RECEIPT DATE: 03/21/2021 **ONSITE SEWAGE DISPOSAL SYSTEM** P 568819

PROPERTY ADDRESS: 5624 DOSA COURT, CLARKSVILLE, MD 21029

Low Pressure Dosing System Report

**SITE PLAN FOR BAT INSTALLATION
 THE WOODLANDS
 5624 DOSA COURT, LOT 2**

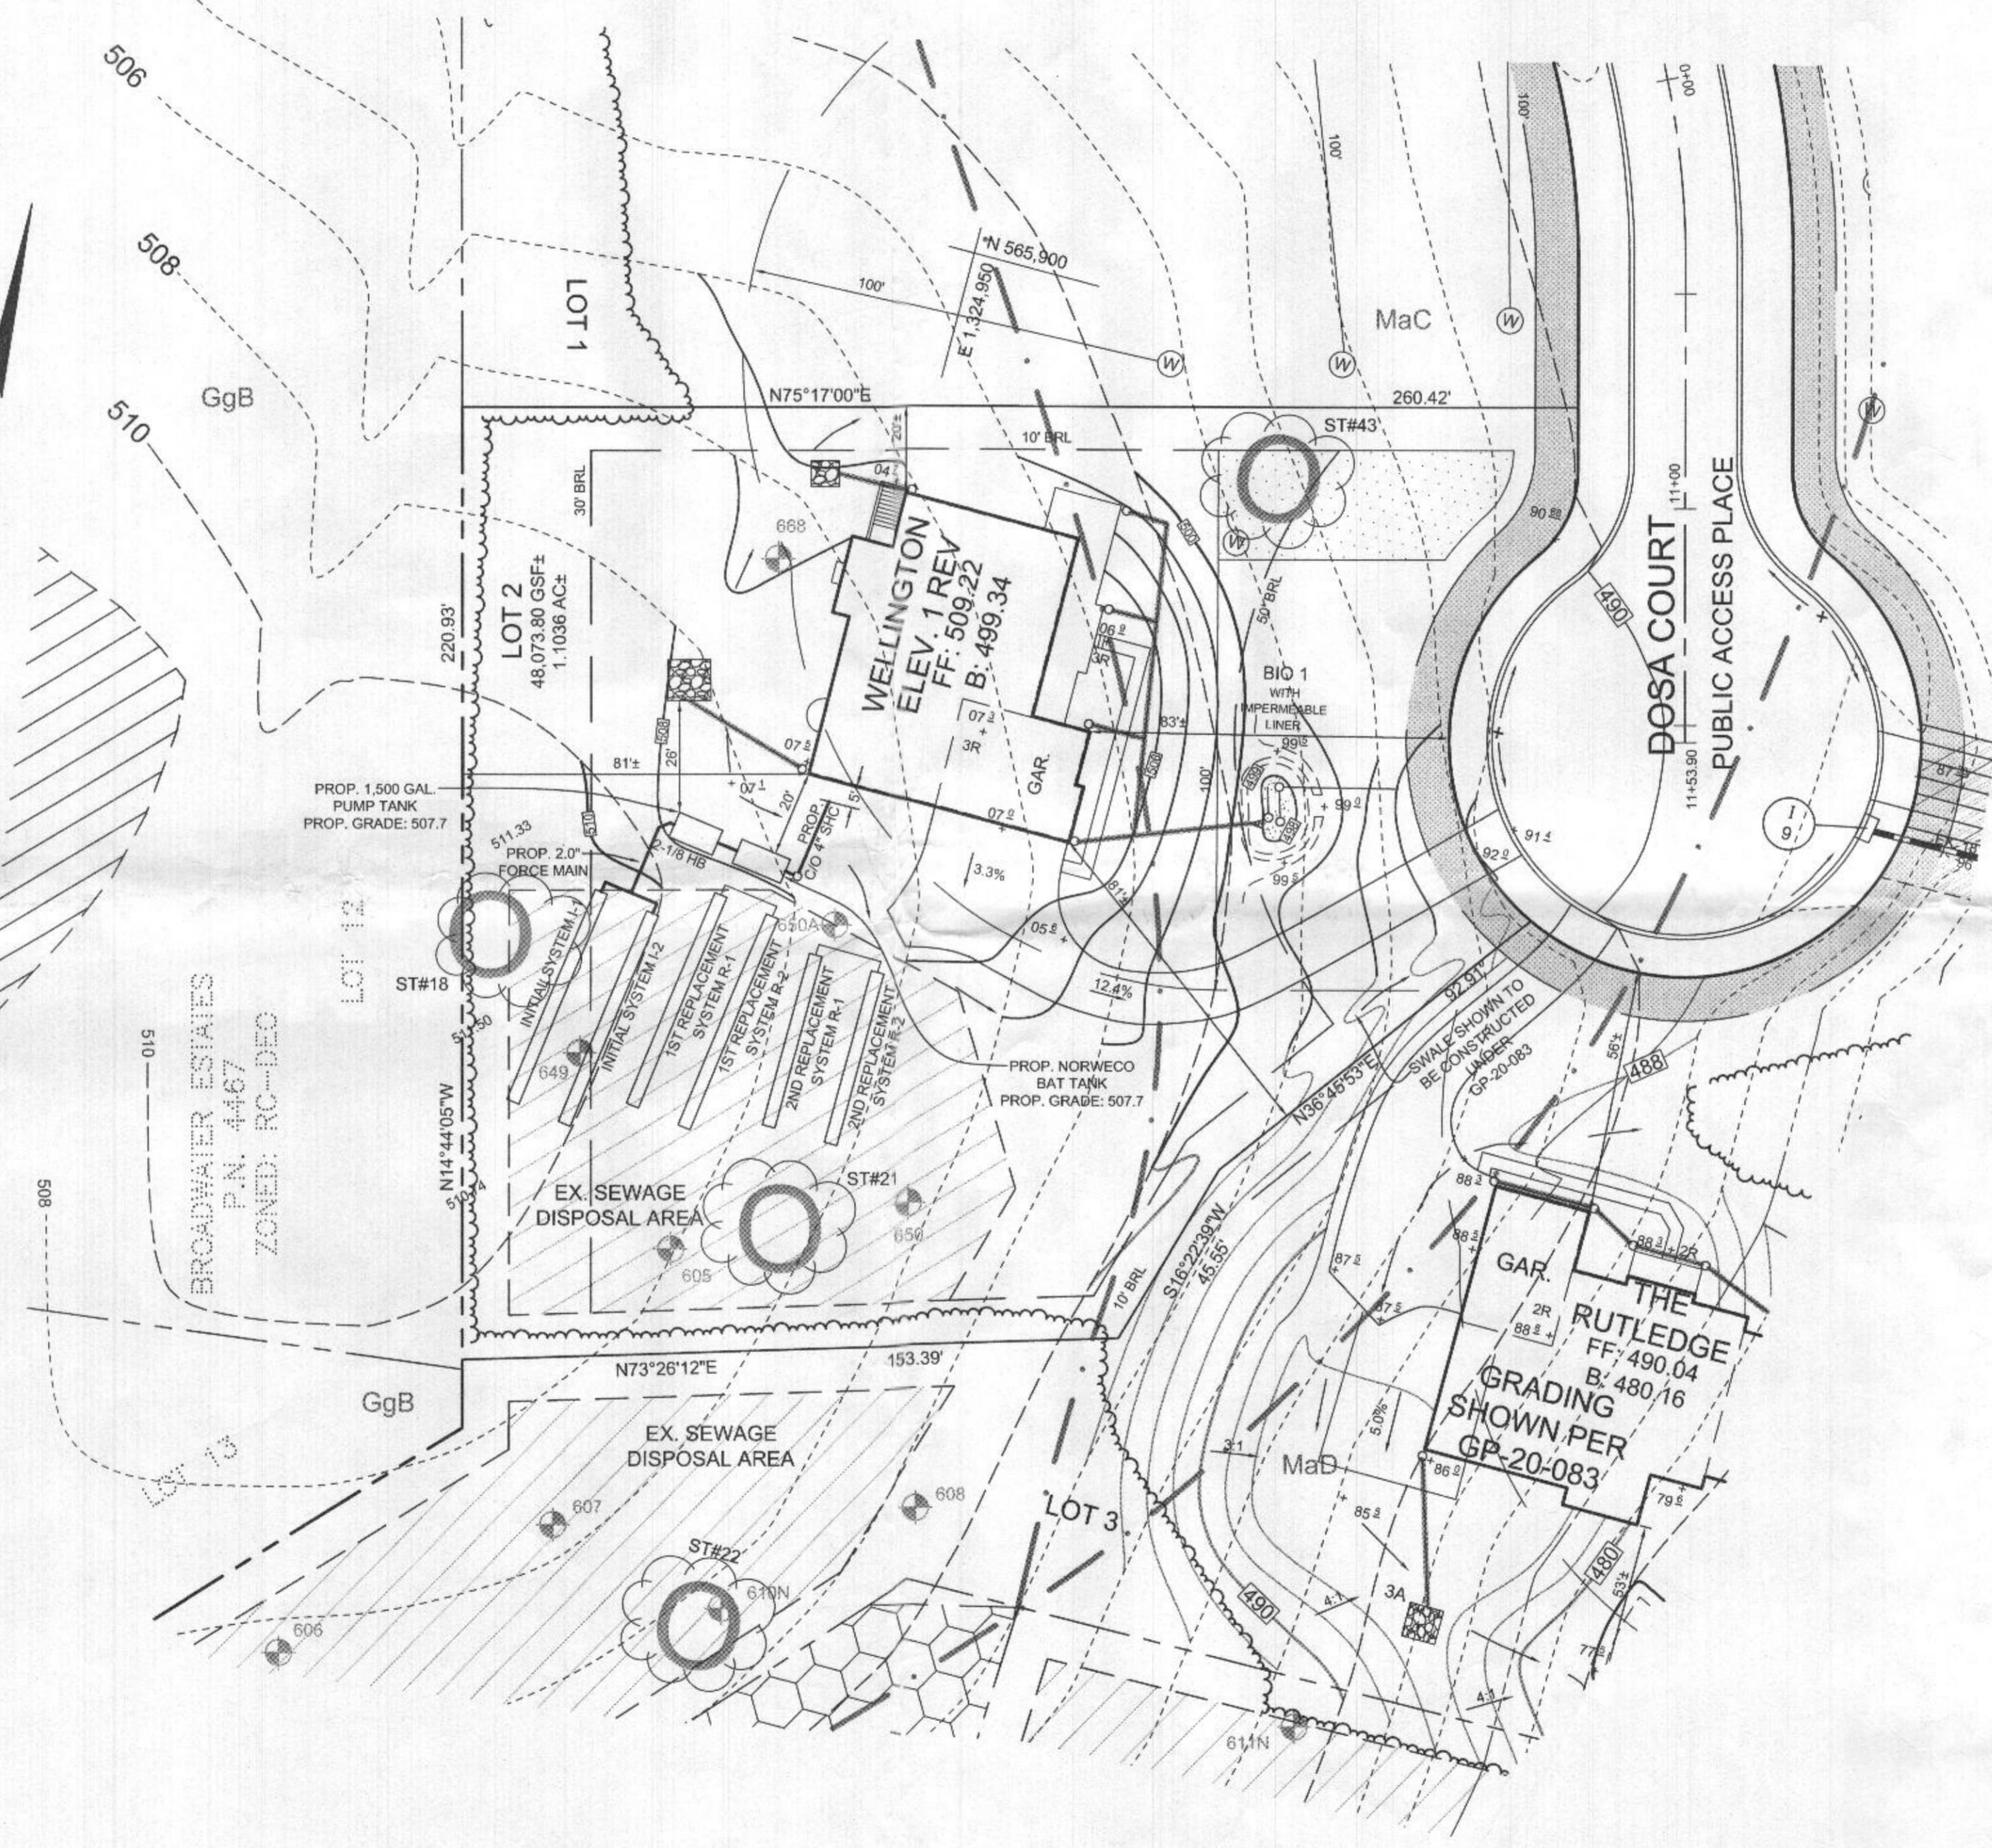
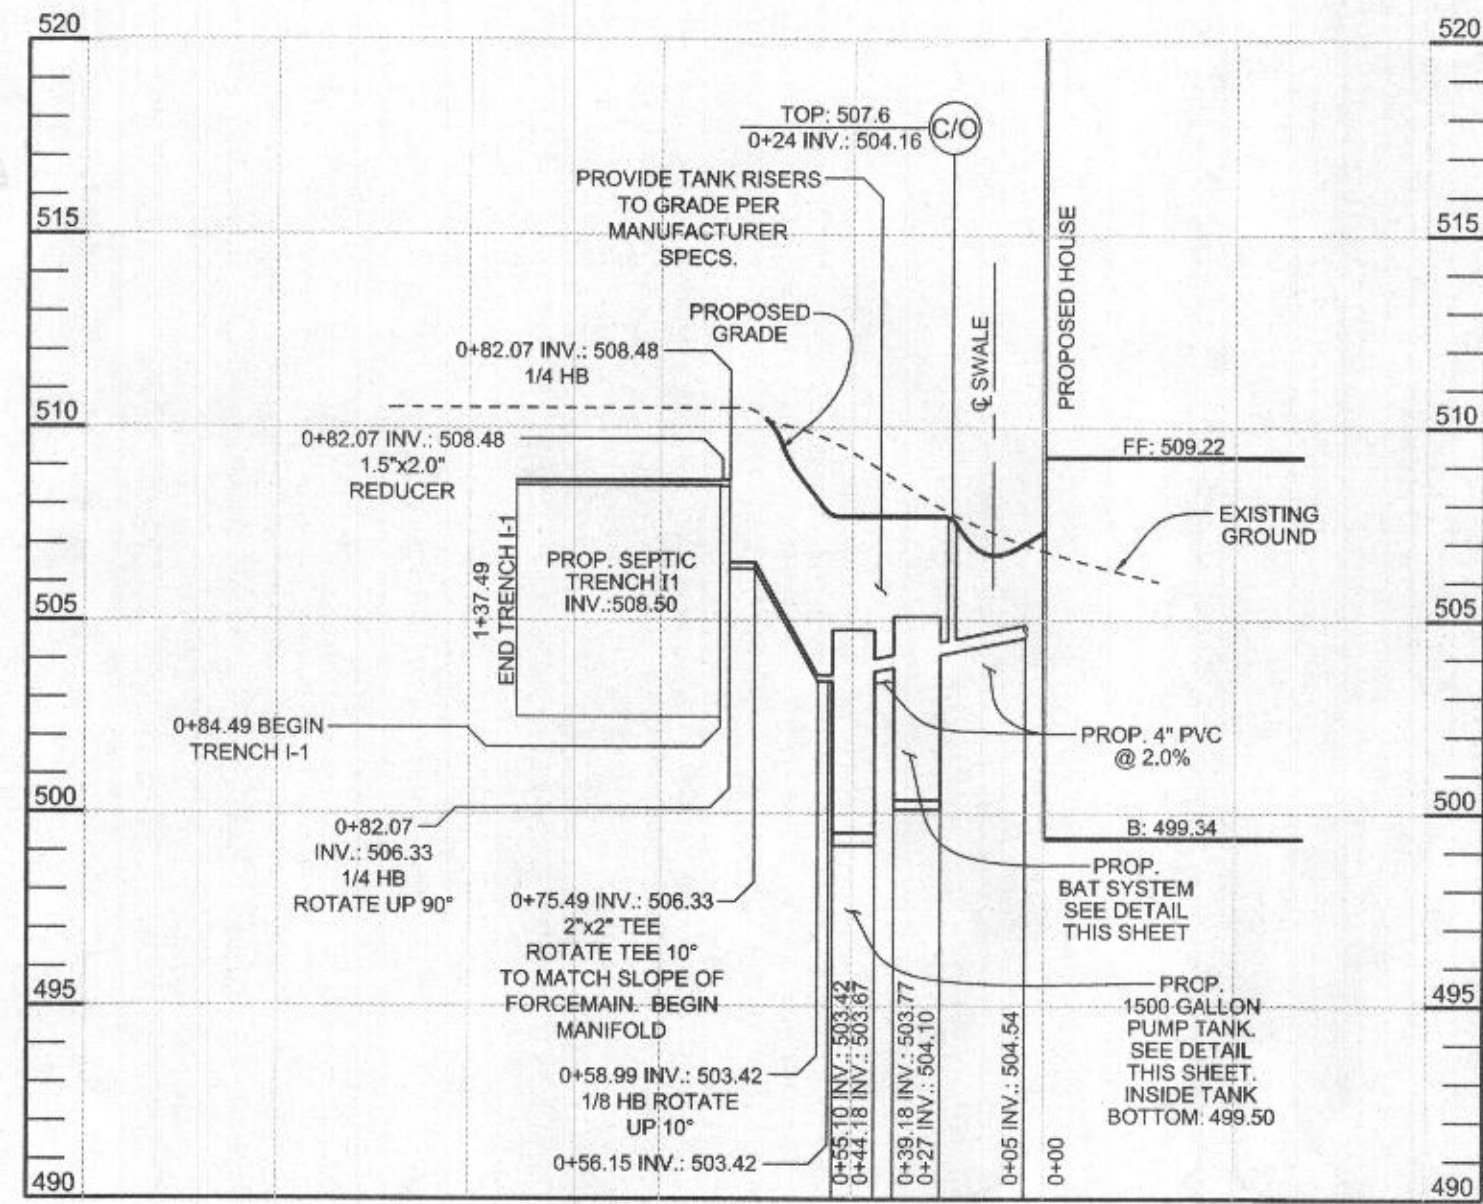
Paul,
Adding to my comments: re-title the calculation for 1st Replacement System trench length and re-calculate length using 3.5 feet as depth for beginning effective absorption area.

The submitted BAT Plan for 5624 Dosa Ct is not approvable at this time.

1. Percolation test locations with correct labels are required content. Include appropriate entries in the Legend.
2. The spacing between perforations in laterals is too wide. I suggest using 10 and 11 perforations for the upper and lower laterals, respectively. This will result in a slightly longer upper trench.
3. The Myers CMV5 pump will not be approved for utilization in the pump tank. The range of operation would not be adjustable without pulling the pump. Additionally, I read the technical data for it and found no mention of interfacing with a control panel required additional float for High Water Alarm. Myers does make pumps appropriate for this application as do other pump manufacturers.

I have reviewed the submitted revision that adds a conservatory and modifies the basement at 5624 Dosa Court (The Woodlands, Lot 2). A revision of the BAT Site Plan is needed for the purposes of updating the footprint of the foundation and for adding capacity to all of the components of the proposed septic system. In essence, the BAT unit, the pump tank and the trench system need to be at design capacity to serve a 6-bedroom residence.

Release of the Septic System Permit for system installation will be held until the BAT Site Plan revision is approved. Also, an Operation and Maintenance Agreement for the BAT unit must be submitted for recording prior to release of the installation permit.
